QUALITY ASSURANCE -- NON-CONFORMANCE REPORT

Location: Changxing Island, Shanghai, China**Report No:** NCR-000815**Prime Contractor:** American Bridge/Fluor Enterprises, a JV**Date:** 26-Jul-2010**Submitting Contractor:** Zhenhua Port Machinery Company, Ltd (ZPMC), Changxing Island**NCR #:** ZPMC-0777**Type of problem:**

Welding	Concrete	Other	
Welding	Curing	Procedural	Bridge No: 34-0006
Joint fit-up	Coating	Other	Component: OBG Suspender Bracket SB78E
Procedural	Procedural	Description: Missed MT transverse cracks by QC

Reference Description: 15 Transverse Cracks discovered with MT testing after ZPMC had tested and accepted these welds

Description of Non-Conformance:

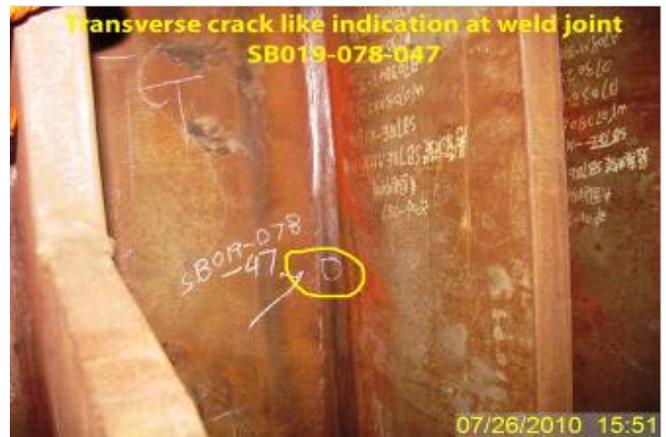
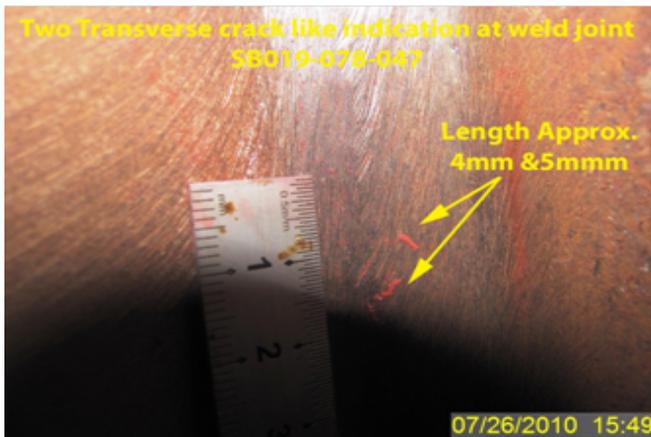
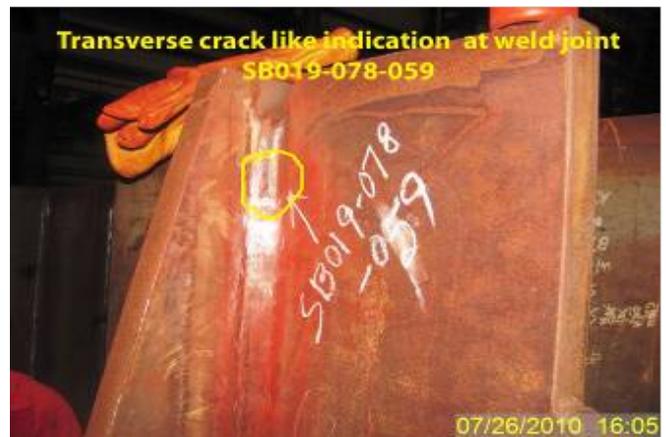
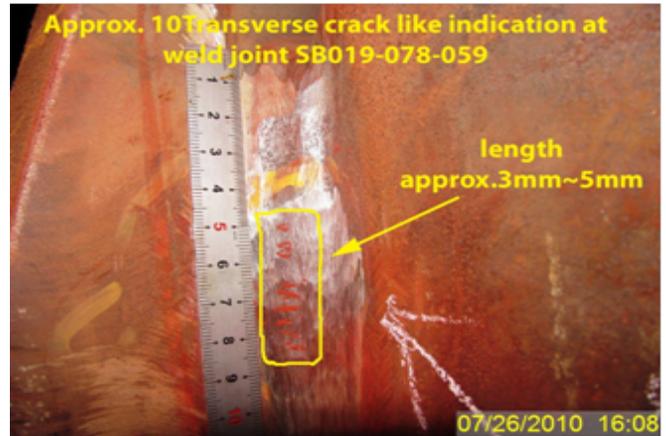
During the Quality Assurance (QA) Magnetic Particle Testing (MT) review of welds located on Suspender Bracket SB78E for Segment 9CE, this QA Inspector discovered fifteen (15) Transverse linear cracks on the following welds:

- Weld # SB019-078-047: Two (2) Transverse linear cracks measuring approximately 4mm to 5mm in length.
- Weld # SB019-078-059: Ten (10) Transverse linear cracks measuring approximately 3mm to 5mm in length.
- Weld # SB019-078-065: Three (3) Transverse linear cracks measuring approximately 3mm to 7mm in length.
- All indications are clearly marked on the material near the weld.
- All welds are designated as Non-Seismic Performance Critical Members (Non-SPCM).
- All welds are fillet welds that join the Middle Web plate (X56CC) to Stiffeners (X55).
- OBG Suspender Bracket SB78E is located in Bay # 19.

The Notice of Witness Inspection Number (NWIT) is 06286. The indications are located inside an area that has been previously tested by ZPMC Quality Control (QC) personnel. As per the contract documents, ZPMC's QC personnel are required to perform 100% MT inspection of this weld.

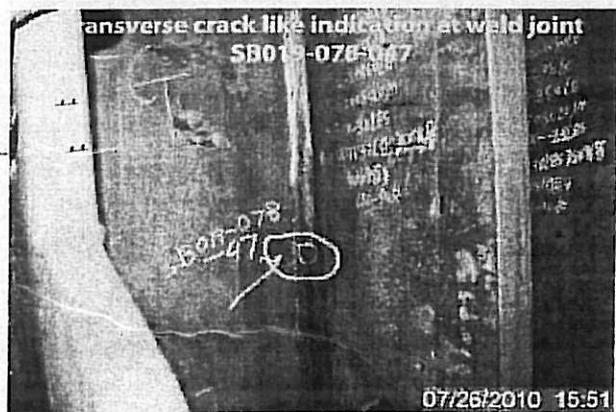
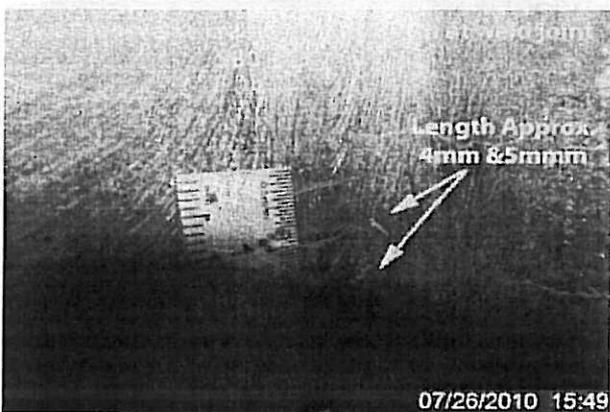
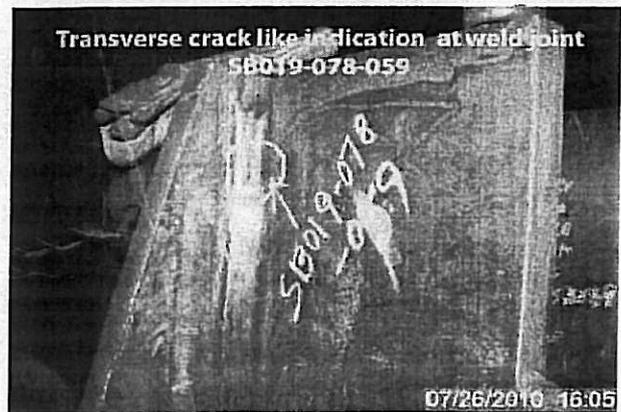
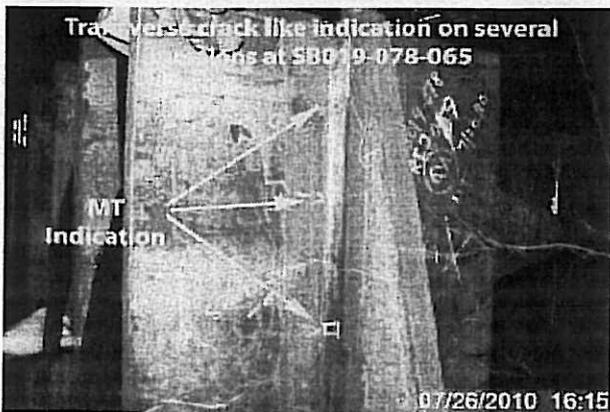
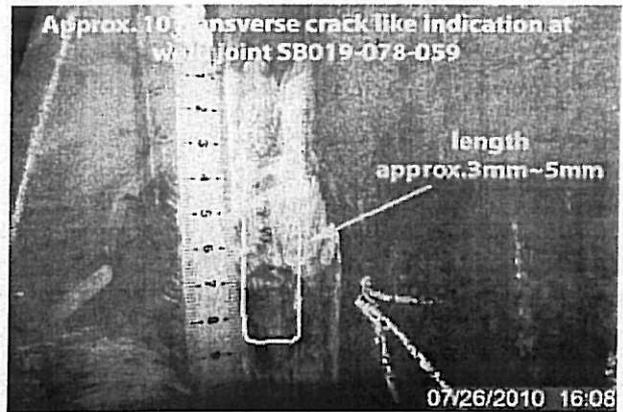
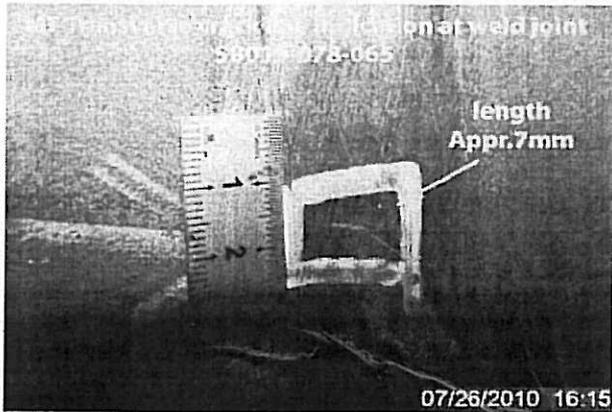
During the Quality Assurance (QA) Magnetic Particle Testing (MT) review of welds located on Suspender Bracket SB78E for Segment 9CE, this QA Inspector discovered fifteen (15) Transverse linear cracks on the following welds:

-Weld # SB019-078-047: Two (2) Transverse linear cracks measuring approximately 4mm to 5mm in length.

-Weld # SB019-078-059: Ten (10) Transverse linear cracks measuring approximately 3mm to 5mm in length.

-Weld # SB019-078-065: Three (3) Transverse linear cracks measuring approximately 3mm to 7mm in length.

-All indications are clearly marked on the material near the weld.

-All welds are designated as Non-Seismic Performance Critical Members (Non-SPCM).

-All welds are fillet welds that join the Middle Web plate (X56CC) to Stiffeners (X55).

Contractor proposes to repair the areas noted in NCR, and submits the MT report to show the repair work is acceptable. Contractor will discuss with inspectors at the work site to ensure that inspectors are aware of the procedure of critical welding repair prior to the repairing work. Contractor will identify and educate the inspector who accepts these welds. Contractor will monitor his working performance.

Contractor repaired the weld areas that were noted in NCR, and provided the MT report. The MT report shows the weld area is acceptable. Contractor discussed with inspectors at the work site to ensure that inspectors are aware of the procedure of critical welding repair prior to the repairing work. Contractor identified and educated the inspector who accepted these welds. Contractor is monitoring his performance.
